URGENT - Field Safety Notice

PHILIPS MX 16-slice Computed tomography x-ray system

Software upgrade from v2.0.0.21479 to v2.0.0.21480

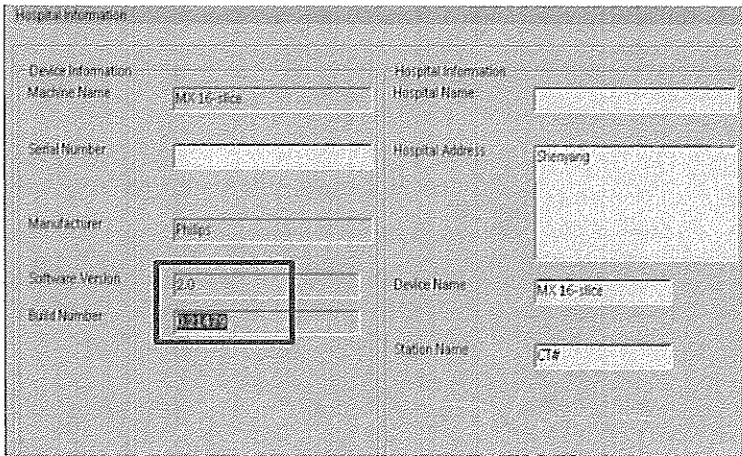
AFFECTED PRODUCTS	Philips MX 16-slice CT Systems with software version v2.0.0.21479
PROBLEM DESCRIPTION	<p>In 2D and Filming function, when image is zoomed and saved as derived DICOM format, the measurement on new created image is incorrect.</p> <p>This issue only occurs on MX16 systems with software version v2.0.0.21479, including MX16 EVO2 systems and MX 16 systems upgraded to MX16 EVO2 using the MX16 iDose4 Upgrade Kit.</p>
HAZARD INVOLVED	Image with incorrect measurement value may be used to guide clinical procedures where measurement is critical. This may lead to misdiagnosis.
HOW TO IDENTIFY AFFECTED PRODUCTS	<p>Identify affected units by the software revision v2.0.0.21479</p> <p>User can identify the existing software version following the steps below:</p> <ol style="list-style-type: none"> 1. Log On the application software with User Name "Config". 2. Click Processing > Service > System Setting> Hospital Information (see Figure 1). 3. Check whether the Software Version is 2.0 and the Build Number is 0.21479 (see Figure 1).  <p>Figure 1: Check the existing software version</p>

ACTION TO BE TAKEN BY CUSTOMER / USER	<p>Do not save images to derived DICOM in 2D. If derived DICOM images are needed, users can save the images in MPR*. Correct measurement result can be obtained on derived DICOM images in MPR.</p> <p>(* MPR is one of the post-processing applications.)</p>
